County of Fairfax, Virginia

March 9, 2016

STAFF REPORT ADDENDUM II

APPLICATION RZ 2015-HM-010

Figure 1- Applicants' Revised GDP

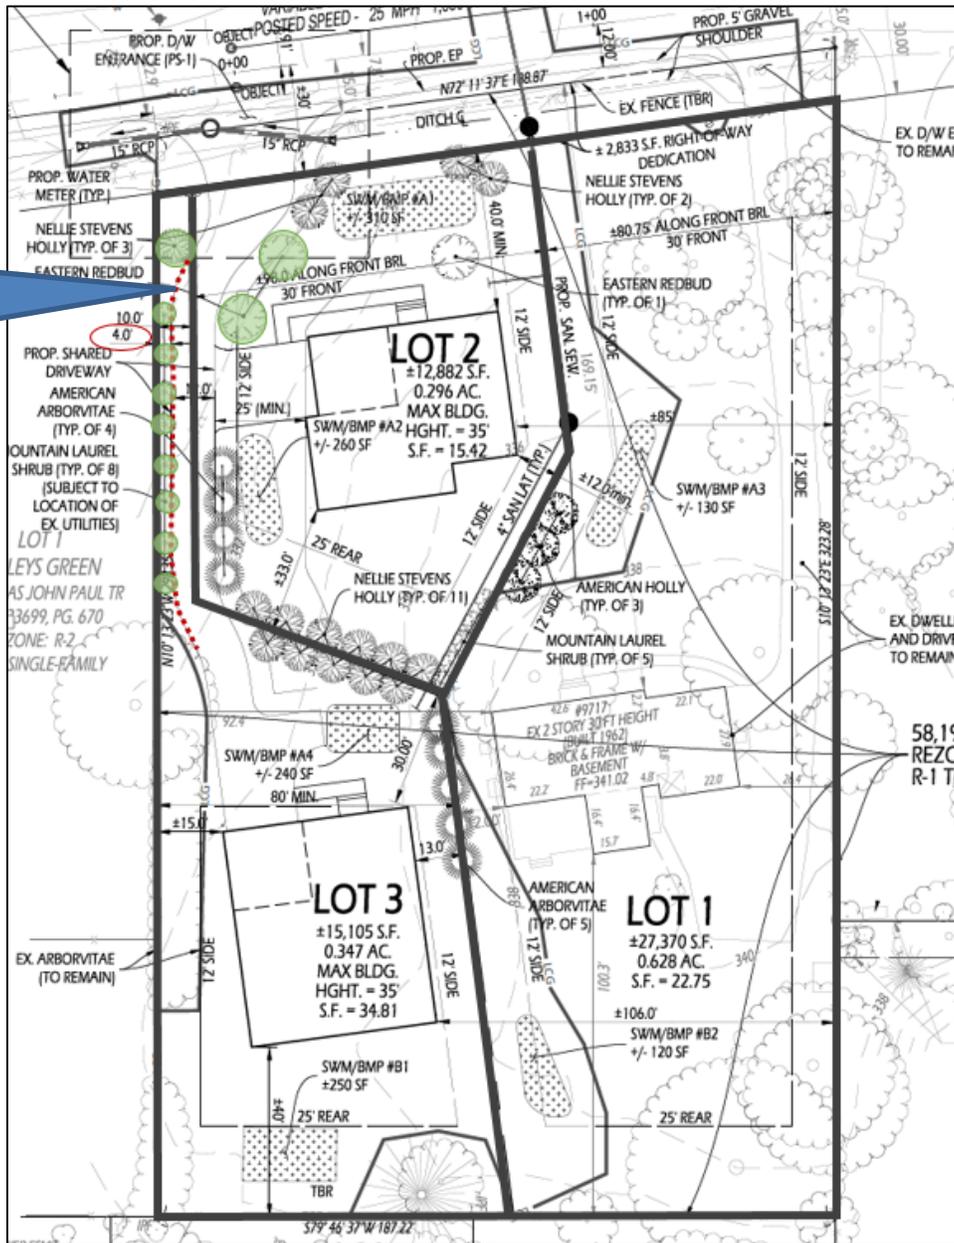
Additional Proposed Landscaping and Modification of Driveway (4ft from property line)

There is no change to the uses on the property. The proposal remains a development with three single family dwellings. Staff's analysis is focused on the minor shift in the driveway location on Lot 2 and increased landscaping for screening.

The applicants have added evergreen landscaping (proposed Mountain Laurel Shrubs) to assist in screening between Lots 2 and 3 and the property to the west. Additional evergreen landscaping have been proposed in the front yard of Lot 2. Staff believes the additional landscaping increases the visual buffer and provides more privacy between the proposed dwellings and the neighboring lots. In addition, previously proposed proffers have been carried over to this addendum including tree preservation, construction monitoring, root pruning, and tree protection that are typically recommended by the Department of Public Works and Environmental Service's (DPWES) Urban Forest Management Division (UFMD).

The applicants revised their GDP to relocate a portion of the driveway for Lots 2 and 3 to be four feet from the western property line to allow for additional plantings. The driveway entrance location from Clarks Crossing Road have not changed. Furthermore, the applicant has proposed additional plantings in the front yard of Lot 2.

This modification request was previously discussed in the staff report dated January 13, 2016 and reaffirmed in the Staff Report Addendum. The minor changes proposed to the GDP do not change staff's analysis and staff does not object to the request.

The proposed density is within the limits specified on the Comprehensive Plan's Land Use Map. While staff would still prefer a two lot layout without the use of a pipestem, staff continues conclude that the proposed development does meet the Residential Development Criteria.
